**City of Wichita
City Council Meeting
October 3, 1995**

SUBJECT: Agreement to Respread Special Assessments in Wilderness at the Park Addition (South of Pawnee, East of Maize) (District V)

STAFF REPORT

CASE NUMBER: S/D 92-14 - WILDERNESS AT THE PARK ADDITION

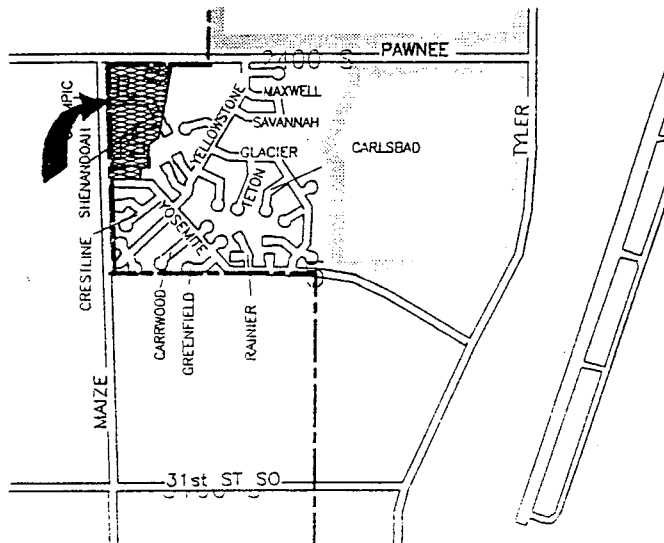
NOTE:As indicated by the first page of the staff report, both the preliminary and final plats for this site have been revised a number of times. This most recent revision is due to the applicant's inability to acquire ownership of a previously platted lot. Without the ownership of the lot or the owner's consent to this plat, the vacation of Olympic Street adjacent to this lot could not be done by means of a replat as previously shown on earlier plats.

Consequently, this final plat has been revised so as to show the lot in question as an exception, with Olympic (Circle) Street being maintained adjacent to the lot. The properties either side of this lot are owned by the present applicant and for now are being platted as Reserves. At some future time, the applicant hopes to acquire the exception area and along with these Reserves and Lot 1 would replat this portion of the site into three (3) conventional lots.

In addition to the above indicated changes, several minor changes have been made in this plat involving lot lines, easements, and the size of Reserve "A" in the area of Maize Road. Overall, however, this plat is substantially the same as originally reviewed by the Subdivision Committee and Planning Commission.

- G. In regard to access controls for Reserves B and C, only the access control to Maize Road from Reserve C is needing to be platted. Access to Olympic Circle and Denene needs to be provided so that these Reserves can be maintained. On

the final plat tracing, the platter's text should be amended by deleting reference to access controls for these Reserves (except to Maize Road).

In terms of Reserves B and C since it is the applicant's intent to keep ownership of these Reserves along with Lot 1 so that the area can be replatted in the future, a separate covenant shall be provided for these properties. In addition to tying ownership and maintenance responsibilities for these Reserves, to the owner of Lot 1, Block 3, this covenant shall also provide that these Reserves cannot be sold separate from Lot 1 until such time as Lot 1, the Reserves, and the additional adjoining areas (exception, Olympic Circle) can be platted into lots.

In the plattor's text, the text shall be amended to note that Reserves "B" and "C" shall be owned and maintained by the Owner of Lot 1, Block 3.

- K. As indicated by City Engineering, the final plat tracing shall indicate minimum building pad elevations for those lots adjacent to the Floodway. It shall be indicated if the elevation(s) are for the lowest opening or floor level. These elevations shall be shown on the face of the plat and also referenced in the platting text. Both on-site and off-site bench marks shall be indicated.
- L. On the final plat tracing, the applicant shall satisfactorily address conflicting information contained between the platting binder and the final plat, specifically but not limited to plat ownership and mortgage information.

- S. Recording of the plat within 30 days after approval by the City Council.
- T. The representative from the City Engineer's office should be prepared to comment on the status of the applicant's drainage plan. Specifically, is the minimum building pad correct, are the boundaries of the floodway adequate and are any drainage guarantees required with the platting of this property?

STAFF REPORT
(Preliminary Plat)

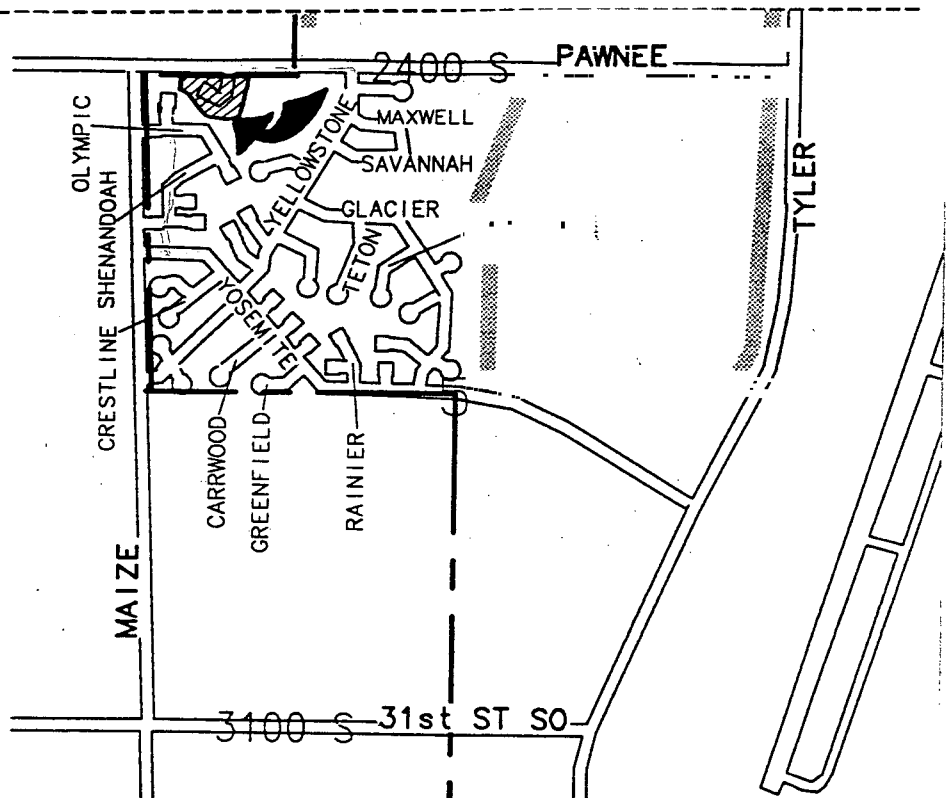
NOTE: This plat involves a replat of a portion of Block 2 of The Park Addition. This area is also within Parcel 1 of The Park Residential Community Unit Plan (CUP) DP-66. As originally platted, a short cul-de-sac off of Pawnee was planned as the access to 17 lots varying in size from 3,500 sq. ft. to lots of approximately 5,000 sq. ft. These non standard lot sizes were being allowed through use of the CUP and apparently were intended for patio or townhouse type dwellings. This present plat is now proposing more conventional single family type development on lots of over 8,500 square feet.

- E. The applicant shall guarantee the paving of the proposed interior streets.
- F. The applicant shall guarantee the paving of Pawnee, to a two lane residential standard, from Maize Road to the east line of the plat. This paving is needed to provide paved access to both Geyser Circle and lots 11 and 12 which are indicated as having access to Pawnee.

- I. The area between lots 5 and 6 would appear to be intended as a Reserve, for drainage purposes. On the final plat, this area should either be indicated as Reserve or included as parts of lots 5 and/or lot 6.

- K. On the final plat, complete access control to Pawnee shall be indicated across the north lines of lots 1 and 10.
- L. Prior to or at the time of submitting the final plat, the applicant shall submit a drainage plan to City Engineering for review and approval.

- P. The representatives from the utility companies should be prepared to comment on the need for utility easements to be platted on this property.
- Q. The representative from City Engineering should be prepared to comment on the status of the applicant's drainage concept. Also, Engineering needs to indicate if there are any requirements for platting a floodway and/or minimum building pad elevations for this site. The area to the south and southeast of this site was within a floodway.

STAFF REPORT

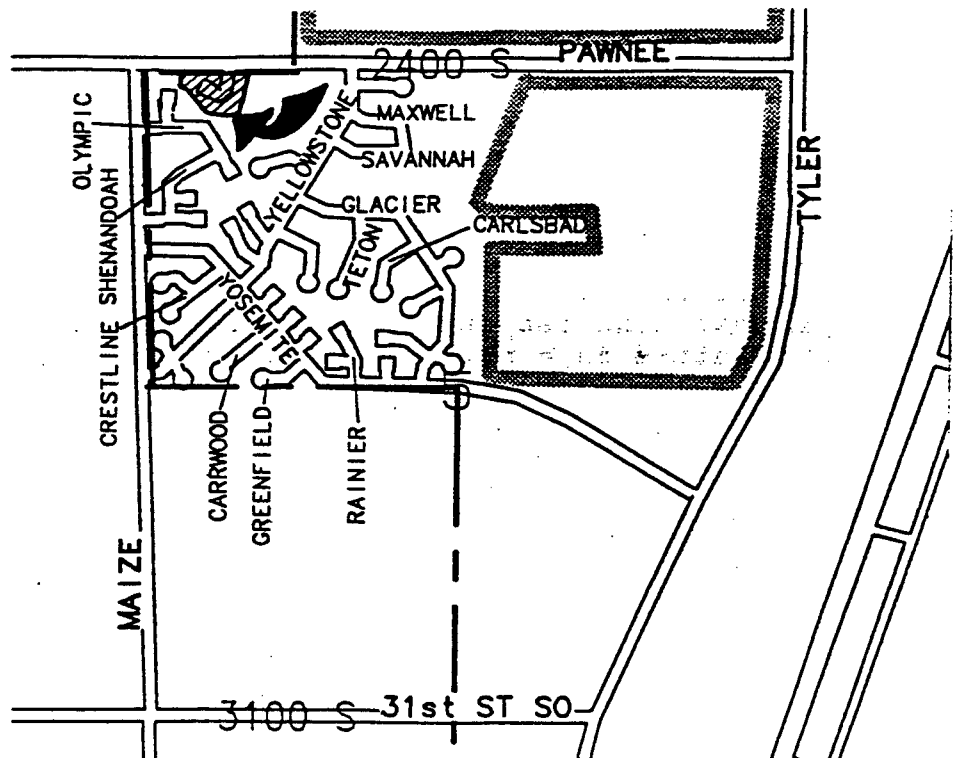
NOTE: This plat involves a replat of a portion of Block 2 of The Park Addition. This area is also within Parcel 1 of The Park Residential Community Unit Plan (CUP) DP-66. As originally platted, a short cul-de-sac off of Pawnee was planned as the access to 17 lots varying in size from 3,500 sq. ft. to lots of approximately 5,000 sq. ft. These non standard lot sizes were being allowed through use of the CUP and apparently were intended for patio or townhouse type dwellings. This present plat is now proposing more conventional single family type development on lots of over 8,500 square feet.

- E. The applicant shall guarantee the paving of the proposed interior streets.
- F. The applicant shall guarantee the paving of Pawnee, to a two lane residential standard, from Maize Road to the east line of the plat. This paving is needed to provide paved access to both Geyser Circle and lots 11 and 12 which are indicated as having access to Pawnee.

- I. The area between lots 5 and 6 would appear to be intended as a Reserve, for drainage purposes. On the final plat, this area should either be indicated as Reserve or included as parts of lots 5 and/or lot 6.

- K. On the final plat, complete access control to Pawnee shall be indicated across the north lines of lots 1 and 10.
- L. Prior to or at the time of submitting the final plat, the applicant shall submit a drainage plan to City Engineering for review and approval.

- P. The representatives from the utility companies should be prepared to comment on the need for utility easements to be platted on this property.
- Q. The representative from City Engineering should be prepared to comment on the status of the applicant's drainage concept. Also, Engineering needs to indicate if there are any requirements for platting a floodway and/or minimum building pad elevations for this site. The area to the south and southeast of this site was within a floodway.

STAFF REPORT

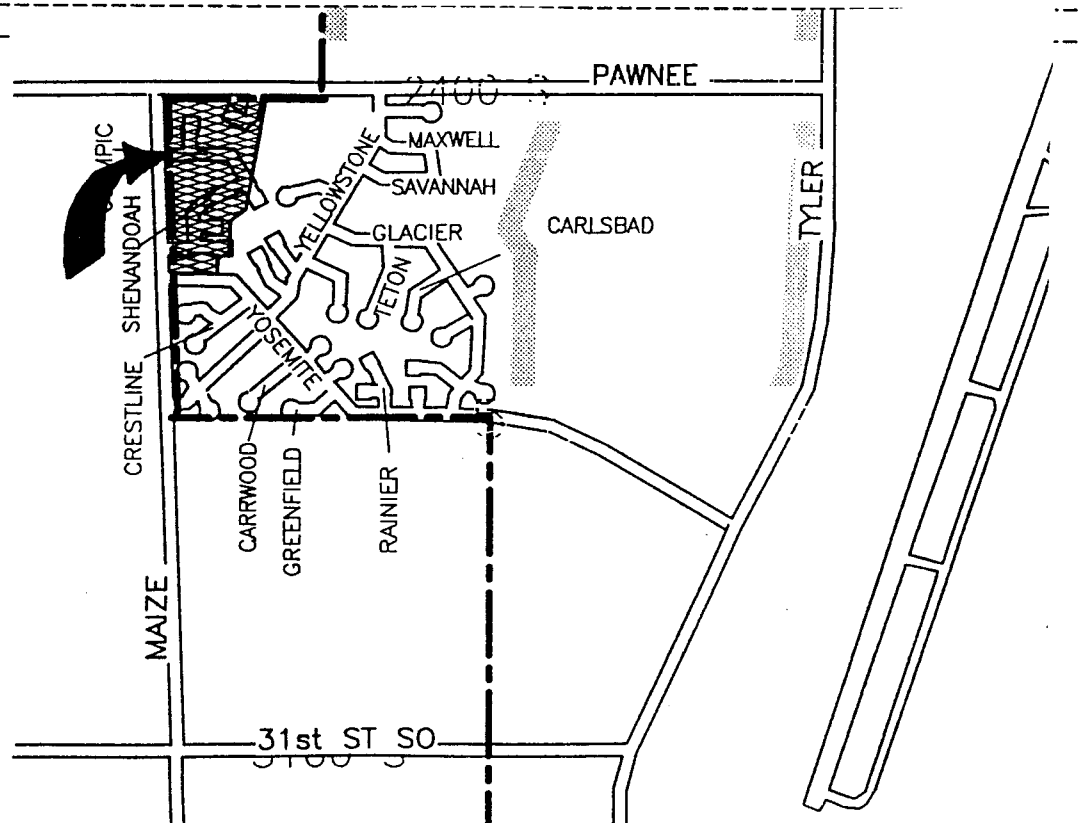
NOTE: A preliminary plat for the area indicated as Block 1, was reviewed by the Subdivision Committee on April 30, 1992. Blocks 2 and 3 of this plat are now being included in this "revised" preliminary. As indicated during the initial review of the preliminary plat, this site is a portion of a previously platted addition, Block 2 of the Park Addition. Also, this site is a portion of Parcel 1, of Community Unit Plan, DP-66. The CUP was originally indicating smaller lot (5,000 sq. ft.) townhouse-type development, but is now being platted for conventional single family homes on lots of over 6,000 sq. ft.

- K. City Engineering shall verify that the requested additional drainage easement, to be located in the area of Pawnee Court, and proposed in the final plat to be located between Lots 7 and 8, Block 1, is satisfactory.

- N. Applicant shall provide an updated platting binder, with an effective date no later than 90 days of its receipt by Planning.
- O. On the final plat tracing, applicant shall satisfactorily address conflicting information contained between the platting binder and the final plat, specifically but not limited to plat ownership and mortgage information.
